W3F1-2004-0111

**SUBJECT:** Supplement to Amendment Request NPF-38-249,  
Extended Power Uprate  
Waterford Steam Electric Station, Unit 3  
Docket No. 50-382  
License No. NPF-38

**Revised Markup of Technical Specification Pages**

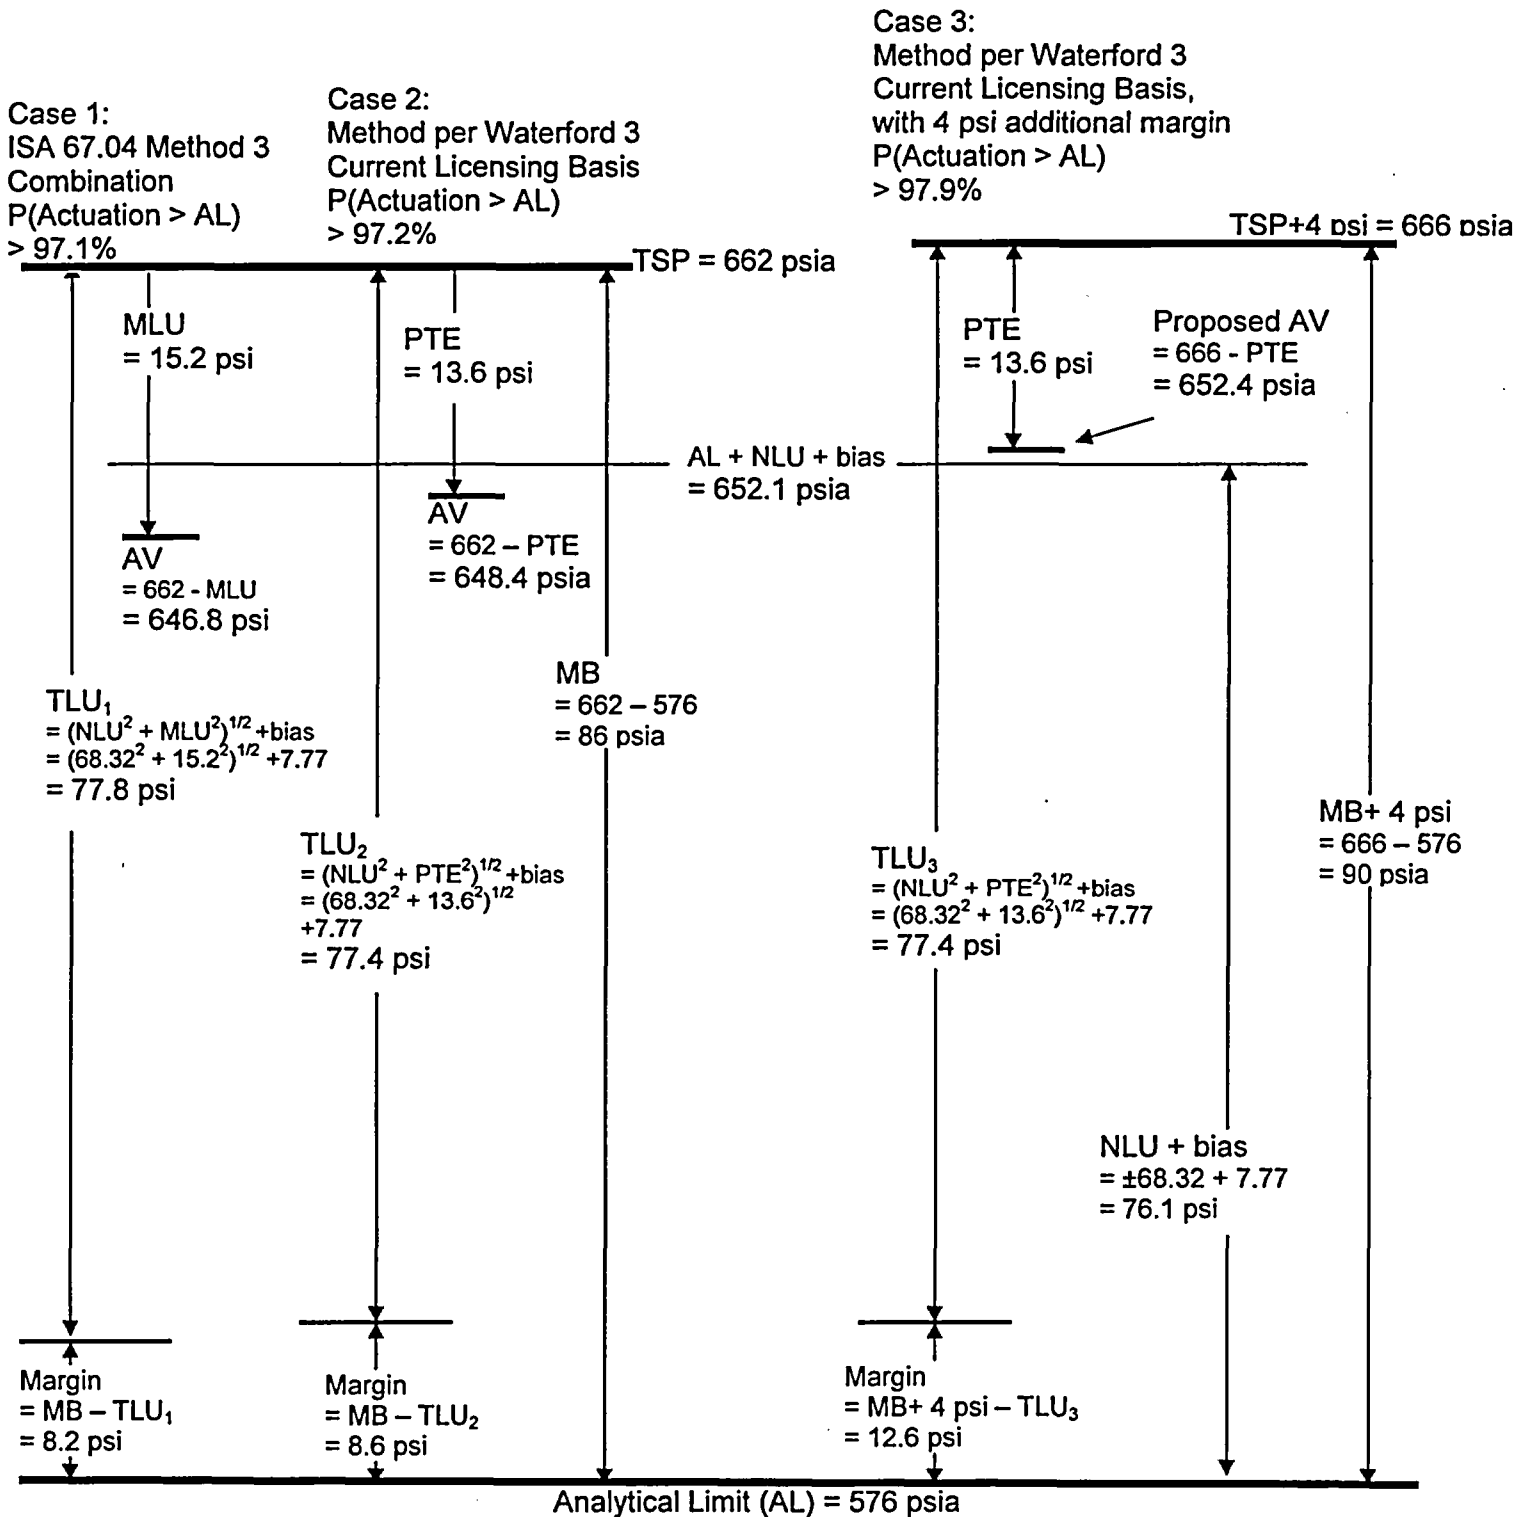
An illustration, provided below, reflects the previously proposed trip setpoint, revised setpoint, and AV as derived using three different methods:

Waterford 3 respectfully maintains its position that the trip setpoint and allowable value using Method 3 does provide adequate assurance the plant will operate in accordance with the plant safety analyses. This is demonstrated in the illustration below which includes the probability that the trip will occur at a value greater than the analytical limit for this parameter for each method. Maintaining the proposed trip setpoint as the limiting safety system setting (LSSS) derived and maintained in accordance with Waterford 3 TS assures with greater than 95/95 confidence the analytical limit will be protected. The allowable value as currently listed in Waterford 3 TS is used to determine that plant protection system trip modules perform as statistically predicted to assure the trip setpoint (i.e., LSSS) protects the AL.

The figure below illustrates the relationship between the proposed trip setpoint, new proposed setpoint, AV and AL, based on three calculation methods. NLU is the combination of the random portion of the non-measurable loop uncertainty effects. MLU is the combination of the random portion of the measurable effects, combined as they would be combined for the derivation of the TLU used to determine the trip setpoint.

Proposed Trip setpoint:	666 psia
Periodic test error (PTE):	<u>-13.6 psi</u>
Proposed allowable value: (Trip setpoint – PTE)	652.4 psia

Analytical limit (AL):	576 psia
Non-measurable uncertainties + bias:	<u>+76.1 psi</u>
AL + Non-measurable uncertainty:	652.1 psia

Thus, the proposed trip setpoint less the PTE is greater than AL plus the non-measurable uncertainties. Entergy believes this addresses the staff's interpretation that the AV protect the analytical limit with greater than 95% probability and with 95% confidence.
